# Lane Cove Council

**Notice of Determination of Development Application issued under the  
Environmental Planning and Assessment Act 1979, Section 4.16**

Development Application No.: DA6/2018

Address: 71-79 Lithgow Street, 82-90 Christie Street, 84A Christie Street,  
546-564 Pacific Highway, Christie Lane, and Lithgow Street, St Leonards

Figure 5.2 Recommended earth pressure distribution

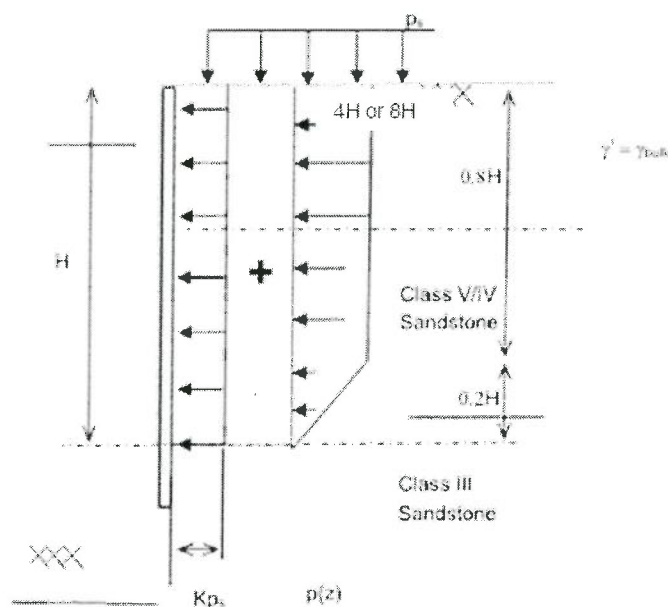
- For rigid walls propped by anchors, internal bracing or floor slabs, the pressure distribution shown in Figure 5.2 could be adopted.
- The design pressure shall generally be between 4H or 8H (kPa), depending on the amount of movement that can be tolerated. 'H' is the effective vertical height of the wall in metres.
- If cantilever or gravity retaining walls are proposed a triangular earth pressure distribution and earth pressure coefficient (K) of 0.35 shall be adopted for soil and Class V or IV sandstone.
